Access Compliance Report

Public Rights-of-Way

(Curb Ramps)

Intersection ID: 4250	Main Street: RADBOURNE_BV	Cross Street: SYMPHONY_WOODS_DR	Location:	N
ADA ID: ECA9F5C0A193	Ramp Type: Perp	Initial Pass/Fail: Fail	Overall Compliance: No	Severity Score: 13.75
Codes/Mitigation Info/Possible Solution		Field Measurements/Component Compliance

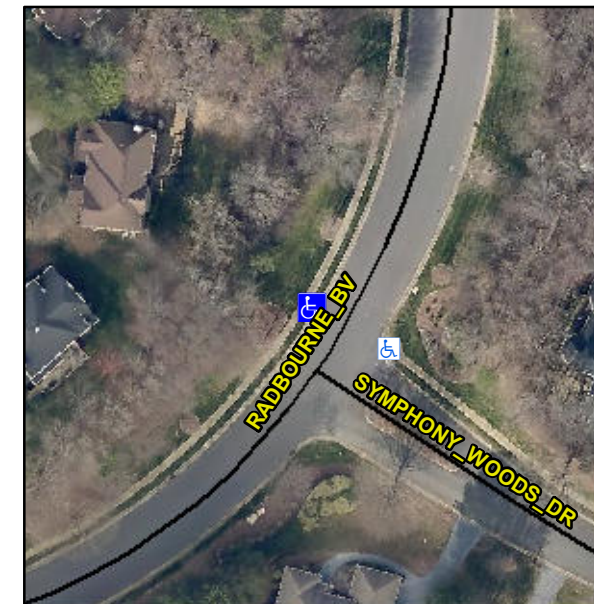
R304.2.2

Compliance	Description	Data	Compliance	Description	Data
N/A	Ramp Length (in)	48.0	No	Ramp Slope (%)	11.7
Yes	Ramp Width (in)	48.0	Yes	Ramp XSlope (%)	2.9
N/A	Flare Type LT	N/A	N/A	Flare Type RT	N/A
N/A	Flare Slope LT (%)	N/A	N/A	Flare Slope RT (%)	N/A
N/A	Flare Traversable LT?	N/A	N/A	Flare Traversable RT?	N/A
N/A	Landing Length (in)	N/A	N/A	DWS Provided?	N/A
N/A	Landing Width (in)	N/A	N/A	DWS Contrast?	N/A
N/A	Landing Slope (%)	N/A	N/A	DWS Length (in)	N/A
N/A	Landing X Slope (%)	N/A	N/A	DWS Full Width?	N/A
N/A	Landing Curb? (Y/N)	N/A	N/A	DWS Offset (in)	N/A
N/A	Shared Landing?	N/A			
N/A	Gutter Ponding?	N/A	N/A	Gutter Slope (%)	N/A
N/A	Gutter Lip Ht (in)	N/A	N/A	Gutter X Slope (%)	N/A
N/A	Painted X Walk1?	No	N/A	Painted X Walk2?	N/A
	X Walk 1 Direction	To SE		X Walk 2 Direction	N/A
N/A	X Walk 1 Width (in)	N/A	N/A	X Walk 2 Width (in)	N/A
	X Walk 1 Slope (%)	5.2		X Walk 2 Slope (%)	N/A
	X Walk 1 X Slope (%)	3.6		X Walk 2 X Slope (%)	N/A

Remove & Replace Entire Ramp.
